RECORD OF PRE-DEVELOPMENT ADVICE

Mingara Recreation Club Seniors Housing, Tumby Umbi (SSD-63475709) – Council Submission

Figure 1: Villa building 11 showing 3 spaces in front of two garages, requiring 2 cars to be moved to access the garage. Note also the tree planted in the centre of the access to the middle space.

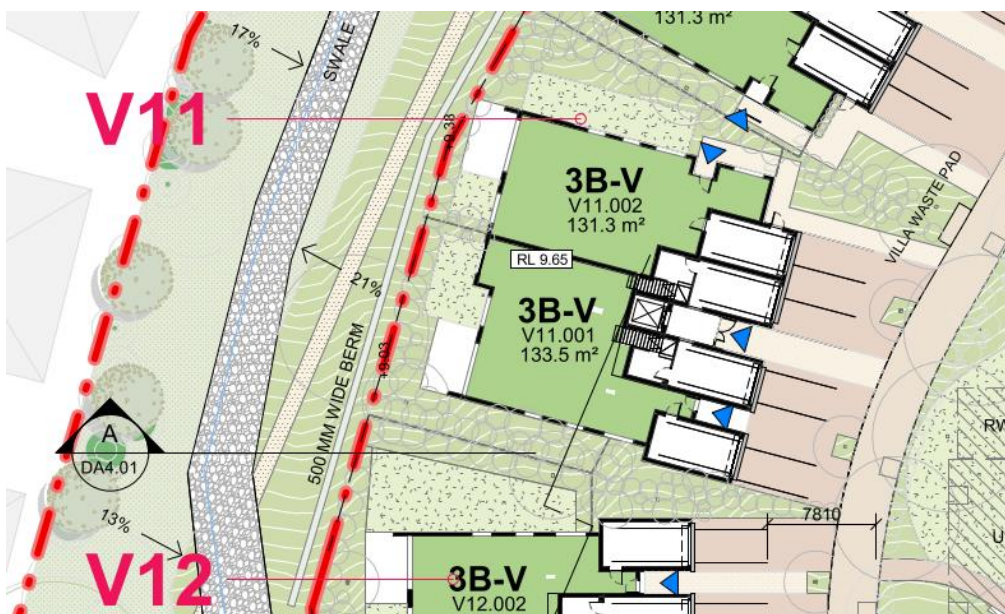
The proposal includes a significant amount of stacked parking. The stacked parking in front of the villa garages is impractical as it blocks access to the garages. Some of the stacked parking shows 3 car spaces in front of 2 garages. Even if the parking is only used by the residents of the villas with garages, 2 cars would need to move for 1 car to access the garage (refer to Figure 1).

- The proposal includes a significant amount of stacked parking. The stacked parking in front of the villa garages is impractical as it blocks access to the garages. Some of the stacked parking shows 3 car spaces in front of 2 garages. Even if the parking is only used by the residents of the villas with garages, 2 cars would need to move for 1 car to access the garage – see Figure 1.
- Some of the car parking spaces have trees located in the centre, garden beds partially located in car parking spaces, some car spaces have no driveway access or will conflict with other parked cars when manoeuvring into the parking space (Figures 2-4).

Figure 2: Trees and garden beds located within the carparking spaces or prevent access to the carparking spaces.

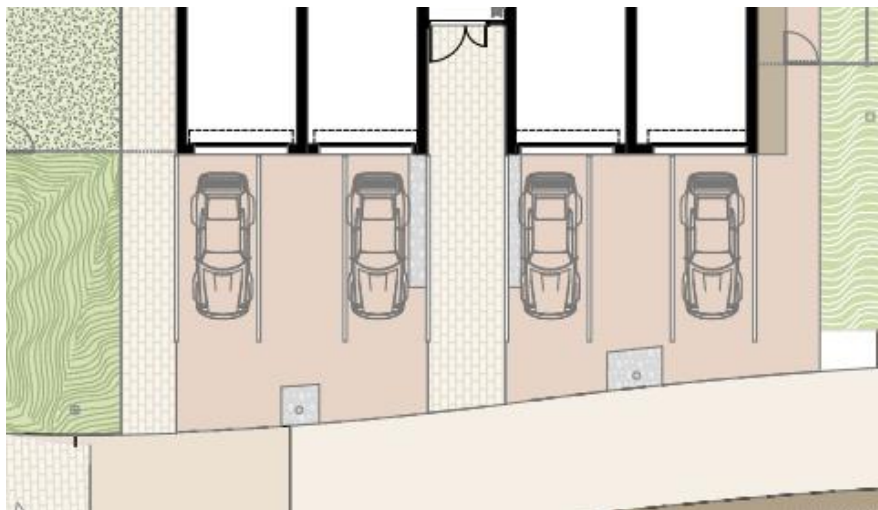
Some of the car parking spaces have trees located in the centre, garden beds partially located in car parking spaces, some car spaces have no driveway access or will conflict with other parked cars when manoeuvring into the parking space (Figures 2-4).

Figure 9: Extract from Fire and Rescue NSW Guidelines showing operation of a specialist fire appliance.

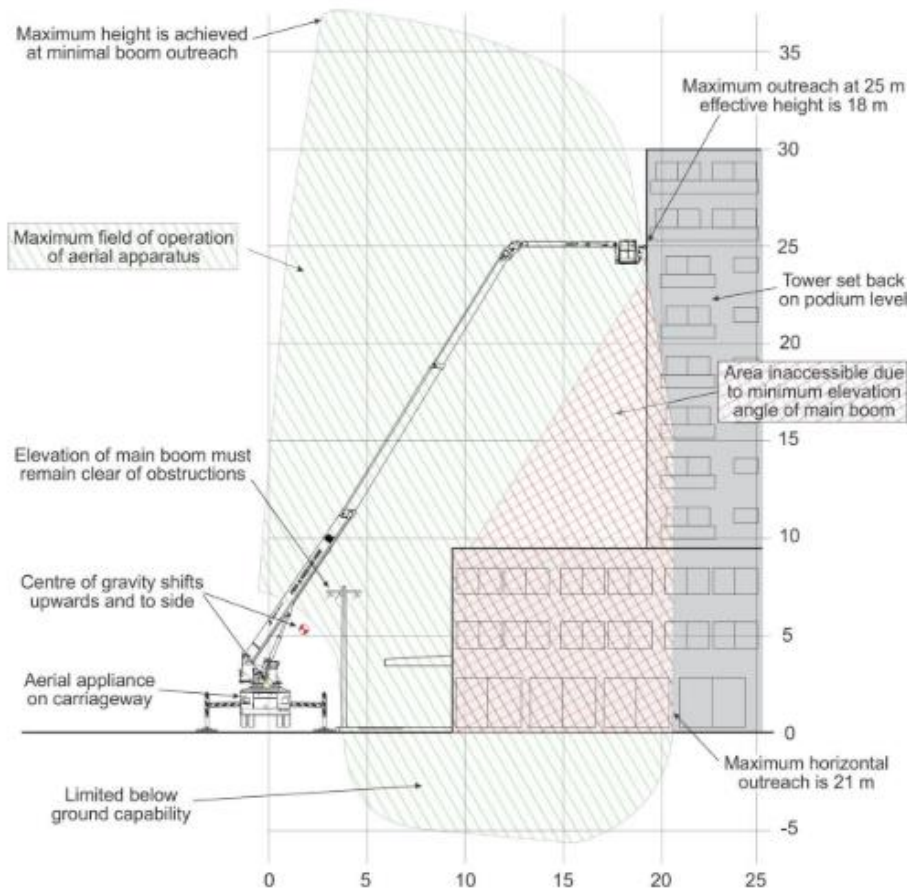
- A minimum 6m wide access around the buildings for a specialist fire appliance to set up the fire truck in a clear space close to the part of the building that is on fire as shown in Figure 9.
